Work Order ID 101369

Item Name: Crosstube Turning Detail

DART AEROSPACE LTD	Work Order:	101369
Description: Crosstube Assembly	Part Number:	D407-667-145
Inspection Dwg: D407-667-145 Rev: C		Page 1 of 2

DRAWING NO. D407-667-145	TITLE CROSSTUBE ASS'Y (407 HIGH FWD)	REV. C	DART AEROSPACE LTD ENGINEERING ORDER		D.E.O. NO. D407-667-145-C-1	SHEET NO. SHEET 1 OF 1	SCALE NTS
DRAWN 97	CHECKED 155	MFG. APPR. 155	APPROVED WD		DE APPR. 155		
DATE 11.07.15	DATE 11.07.22	DATE 11.07.22	DATE 11/07/22		DATE 11.07.21

DETAIL P
BONDING STRAP INSTALLATION 2 PL

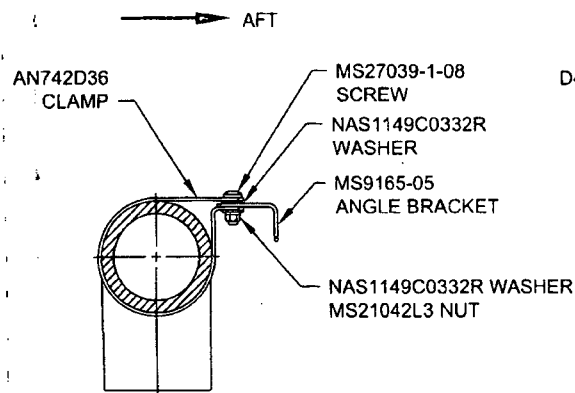
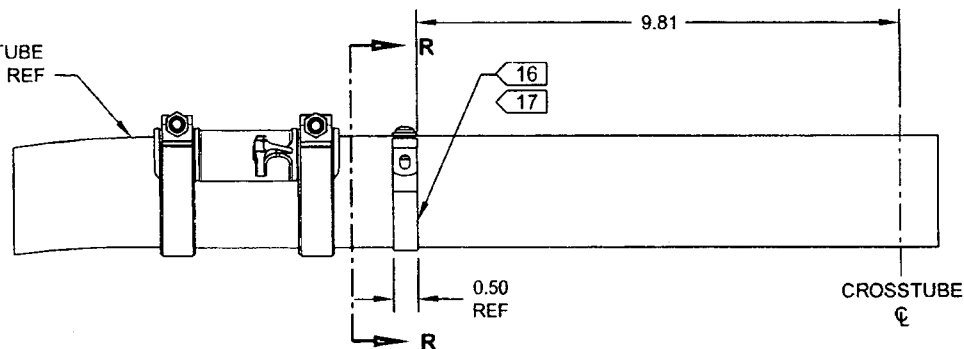
ADD ELECTRICAL GROUNDING STRAP

ITEM	QTY -145	PART NUMBER	DESCRIPTION
1	X	D407-667-145	CROSSTUBE ASSEMBLY (407 HIGH FWD)
10	2	AN742D36	CLAMP
11	2	MS9165-05	ANGLE BRACKET
12	2	MS21042L3	NUT (OR MS21042-3)
13	2	MS27039-1-08	SCREW
14	4	NAS1149C0332R	WASHER (OR AN960C10L)

- 16) MASK AREA UNDER CLAMP PRIOR TO PAINTING
- 17) SEAL EDGES WHERE AN742D36 CLAMP MEETS WITH THE CROSSTUBE USING SIKAFLEX-241/-291 OR MIL-S-8802 CLASS B2 OR PROSEAL 890 SEALANT
- 18) PERFORM RESISTANCE CHECK TO ENSURE MAX RESISTANCE IS 10 MILLIOHMS
